PIC10F200/202/204/206 Rev. A Silicon/Data Sheet Errata

The PIC10F200/202/204/206 parts you have received conform functionally to the Device Data Sheet (DS41239D), except for the anomalies described below.

FIGURE 1:

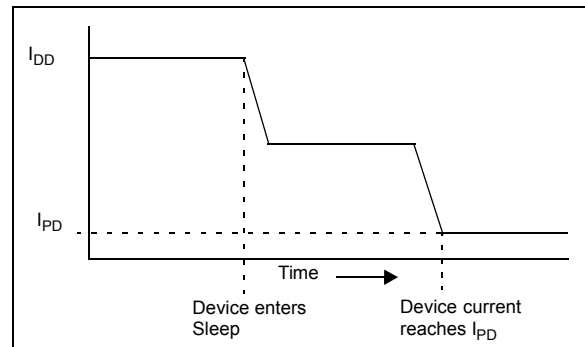
3. Module: I_{PD} , Power-Down Base current

On the PIC10F200/202/204/206 silicon, revisions earlier than A3, the power-down base current may remain higher than the specification for a short time when entering Sleep.

The following graph illustrates the device current upon entering Sleep:

The length of time between the device entering Sleep mode and the device current reaching I_{PD} increases as both temperature and voltage decrease.

This issue is fixed in Rev. A3 and later.
